# SERVICE BULLETIN

No. 525

Piper Aircraft Corporation

Subject: Pilot/CoPilot Seat Latch Mechanism Modification

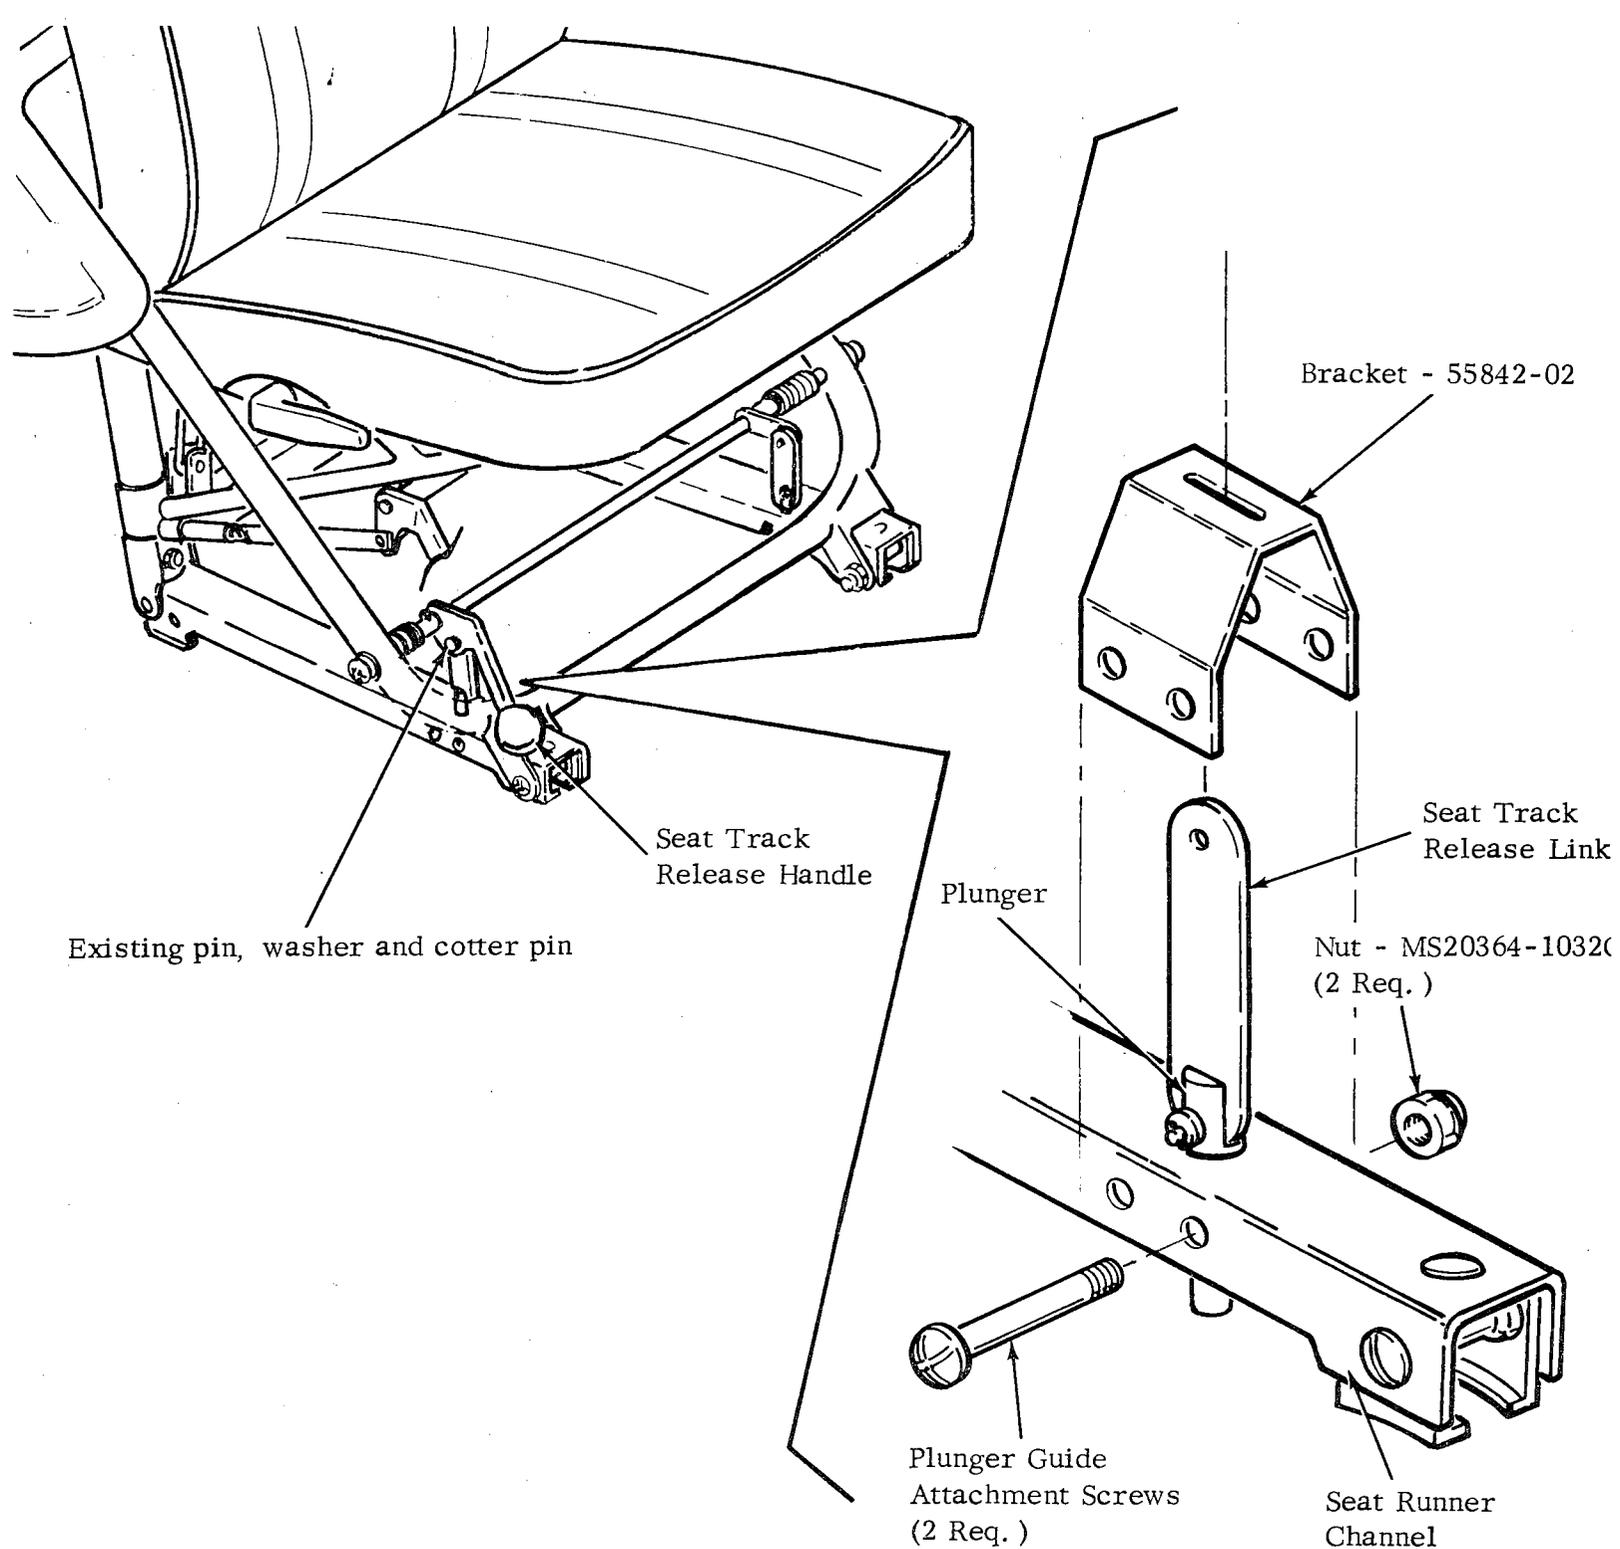
Purpose: A report has been received from the field describing a condition in which the pilot's seat latch mechanism plunger jammed in the "up" position, failing to relock upon release of the seat adjustment lever. This condition could permit inadvertent fore and aft travel of the pilot/copilot seat.

This service release provides material and instructions to install a bracket over the plunger/ seat track release link assembly to prevent excessive upward movement of the plunger, thus insuring relocking of the plunger when the seat adjustment lever is released.

Instructions: Refer to attached sketch/instruction sheet for seat frame bracket installation details.

1. Remove the pin, washer and cotter pin attaching the seat track release link to the seat track release handle, as shown above. Retain hardware for reinstallation. Do not remove link and plunger assembly from seat runner channel.
2. Remove the two plunger guide attachment screws as shown above. Retain screws for reinstallation and discard cap nuts.
3. Install bracket 55842-02 to seat runner channel, as shown above, using the two existing screws and two new MS20364-1032C nuts (procure nuts locally).
4. Attach seat track release link to seat track release handle using existing hardware as shown.
5. Make proper logbook entry of Service Bulletin 525 compliance.
